5AAP

TO	Whom It May Concern	EASD Territory Plan Unit
FROM	Alastair MacCallum	DATE 3 rd September 2011 PAGES 1
ITEM	Draft Variation No. 306

5AAP are a group of Canberra-based architectural practices who, since 2005, have been providing constructive feedback to ACTPLA (now EASD) on a range of planning issues and EASD service delivery. As a group we have recently reviewed DV 306 and provide the following comments for your consideration noting that we have also included a number of examples of completed residential developments including single dwelling to small and larger scale multi-unit development to demonstrate the impact of the proposed new Solar Envelopes. We believe there could be value in 5AAP meeting with EASD to present these 3d models to assist your team visualise the outcomes of the new solar envelopes against a range of previously approved developments.

Example 8 - Building Envelope Comparisons – Single detached residences

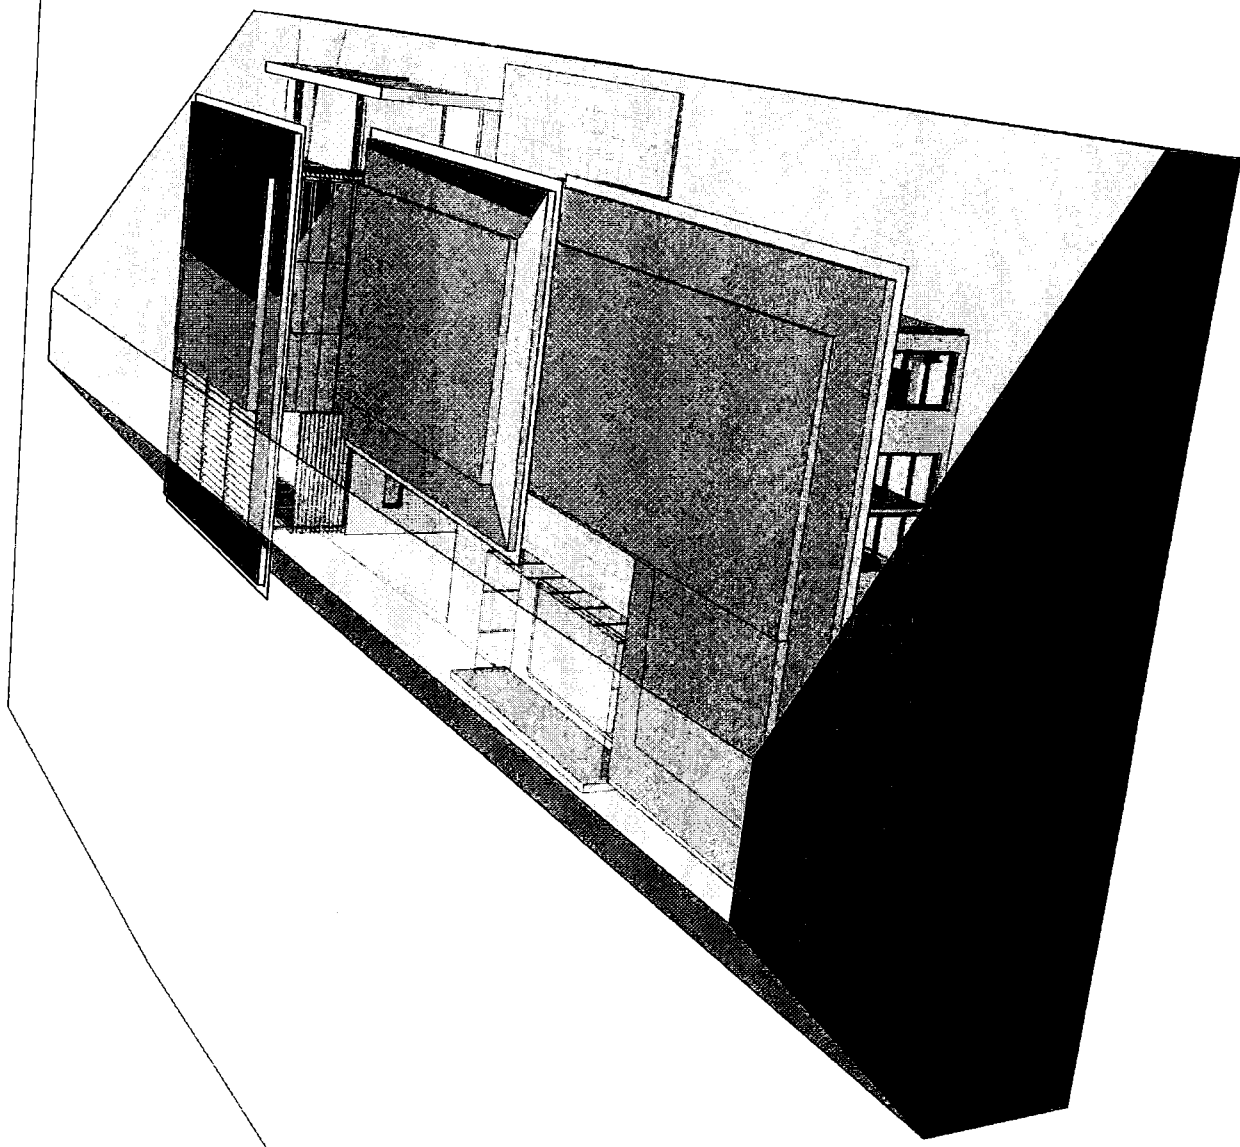
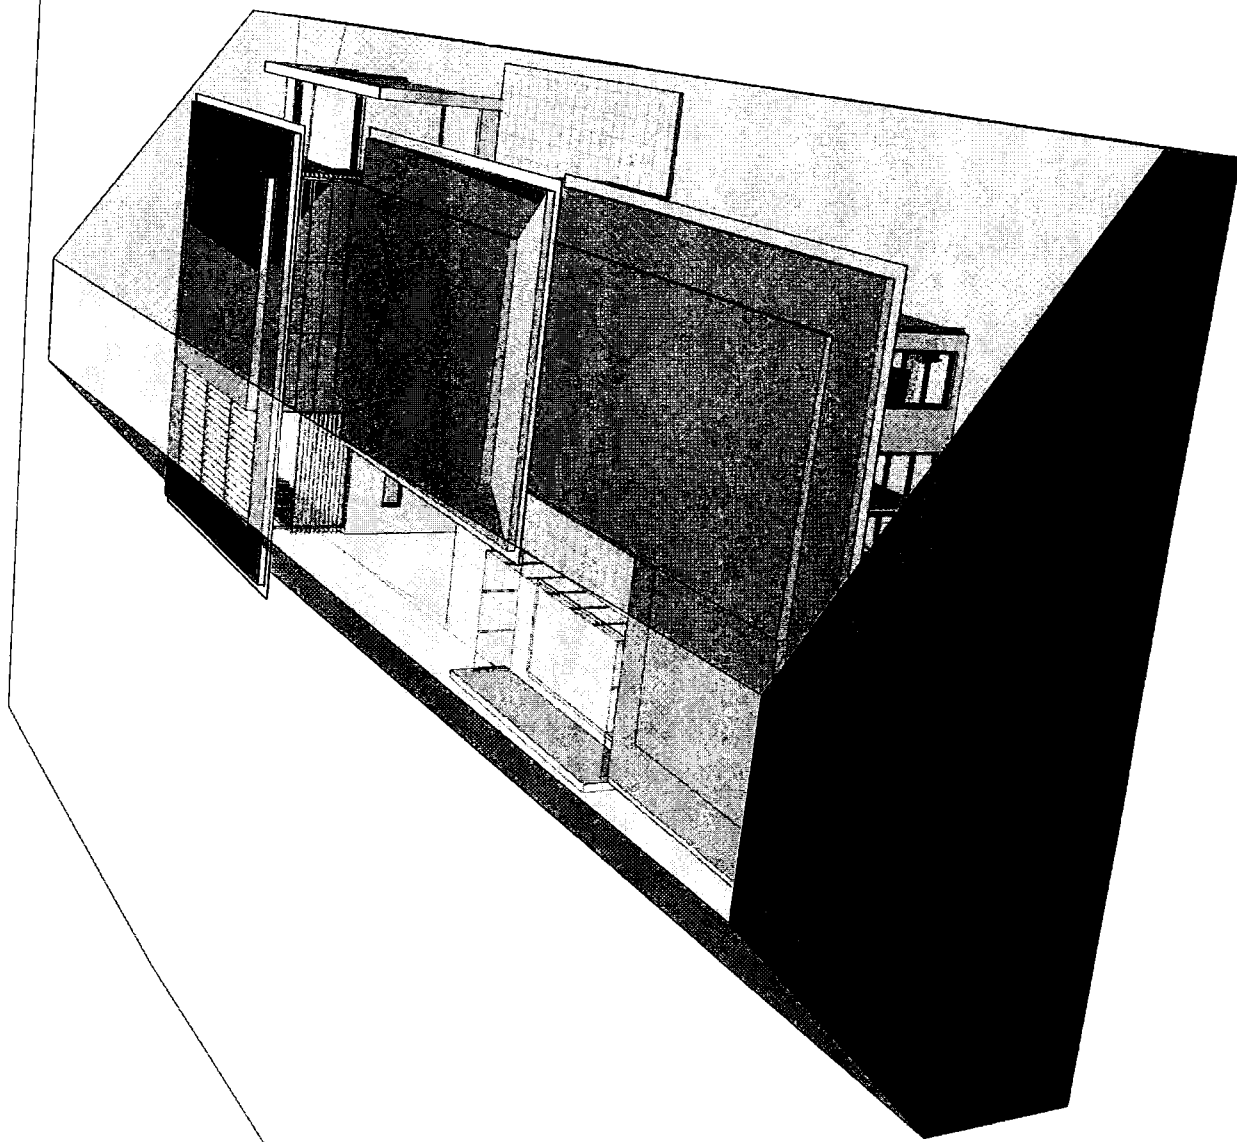
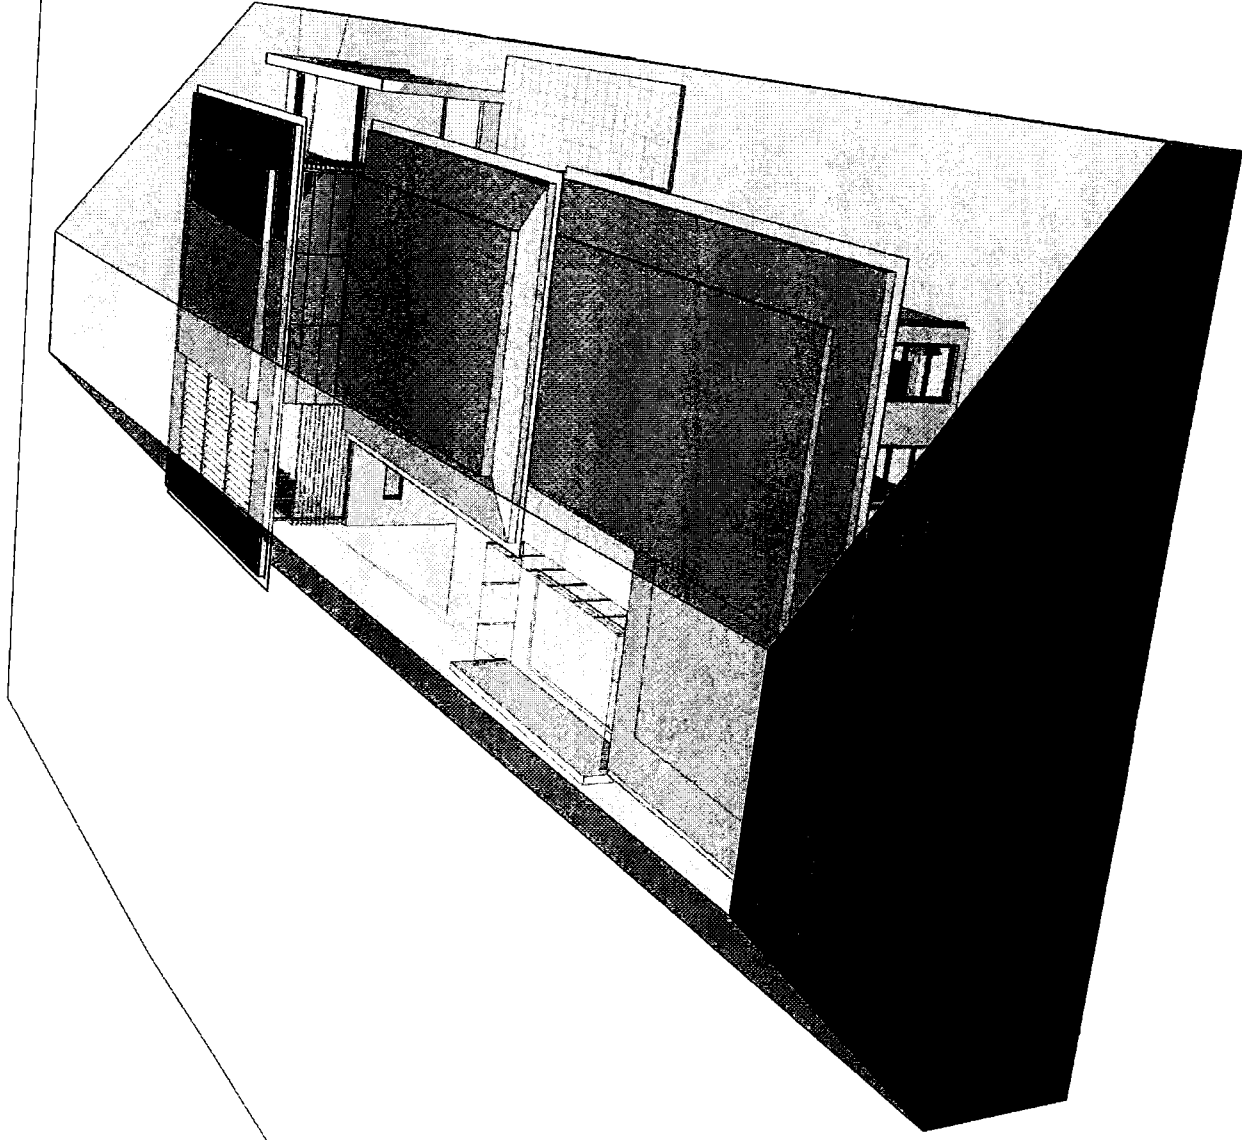
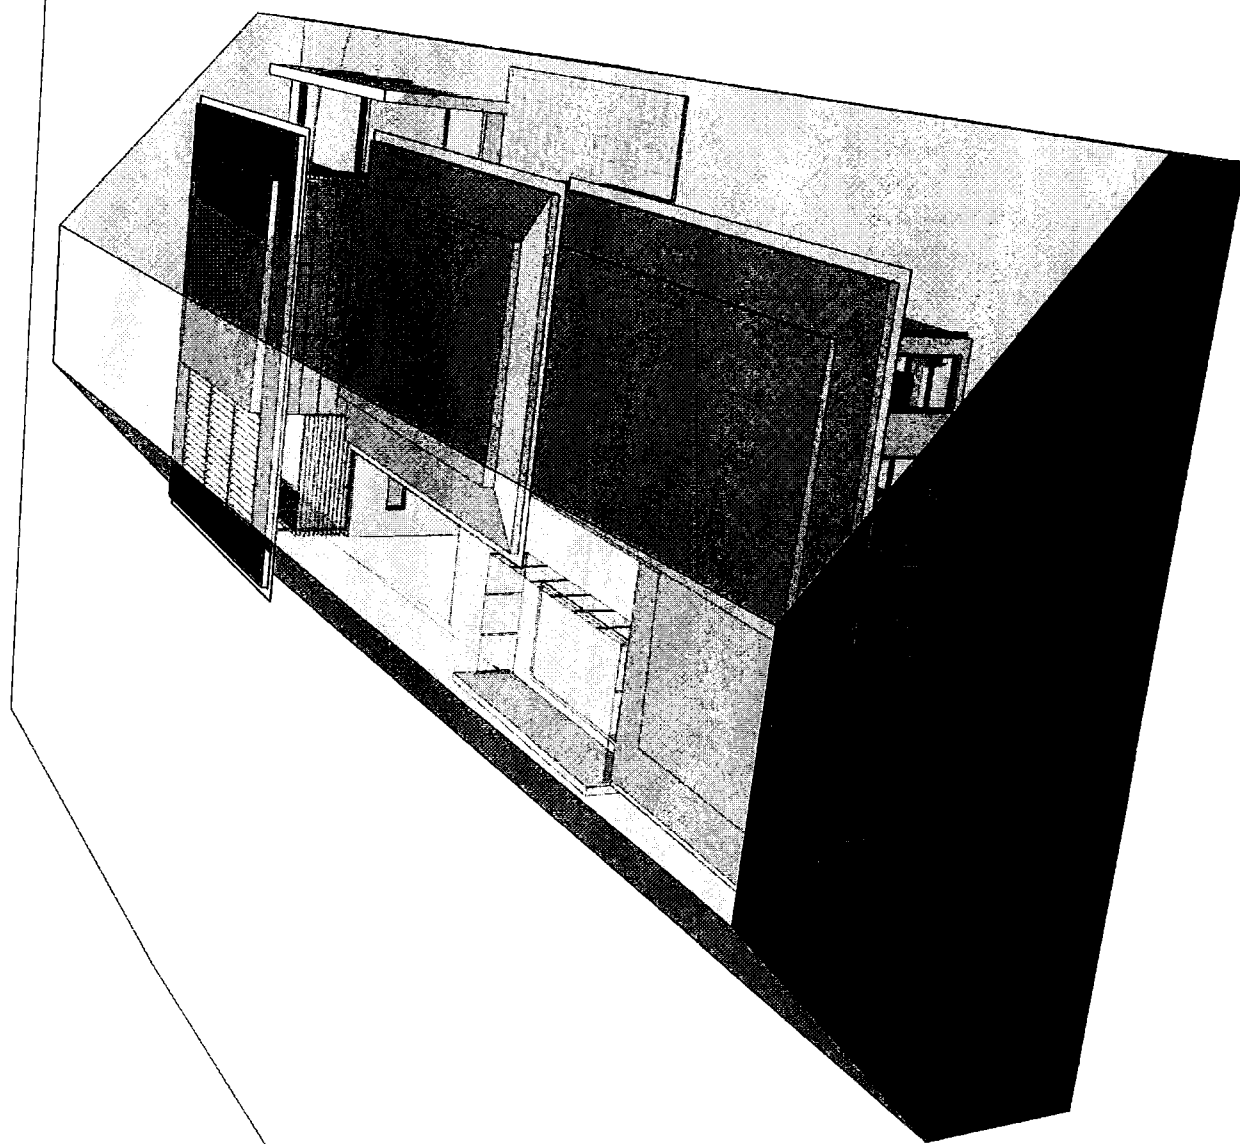
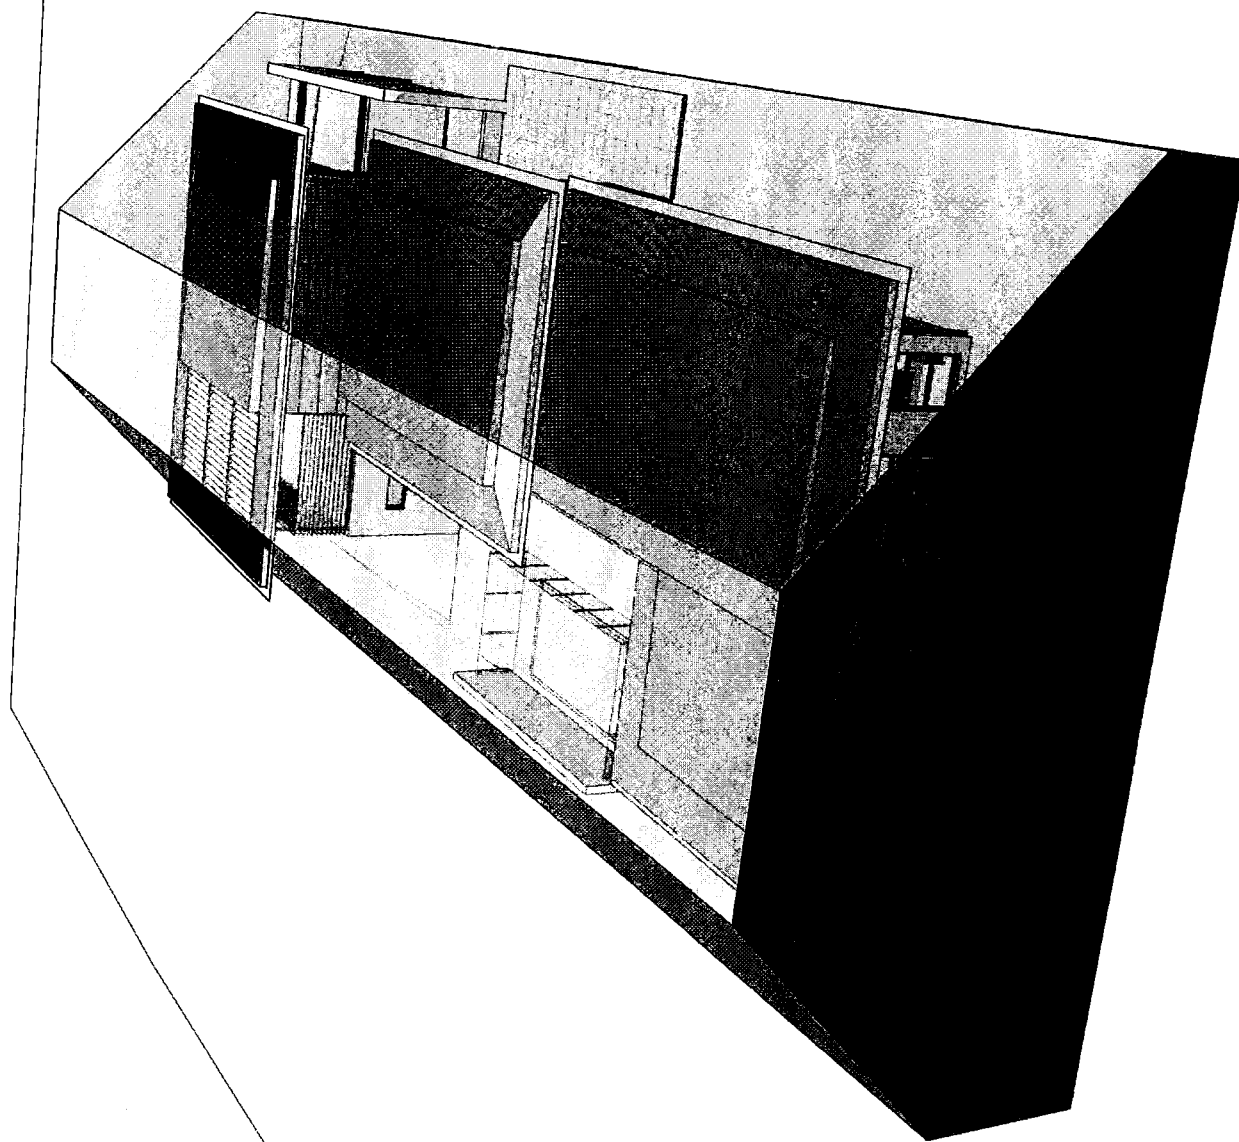
- We are very concerned that new envelope controls associated with residential subdivisions will result in repetitive design solutions, particularly when it comes to smaller block sizes. DV306 increases the level of planning control and in doing so restricts diversity. Of particular note the new building envelope requirements are forcing houses on smaller blocks to two storey solutions that are further restricted to a small strip / zone in the centre of the block (the *wedding cake* solution) which is increasingly evident in new suburbs. At the same time it may make it more difficult for residents to adapt their homes to meet the changing/ growing needs of the family which we also see as a negative outcome given it will be harder to extend residences with tighter controls.
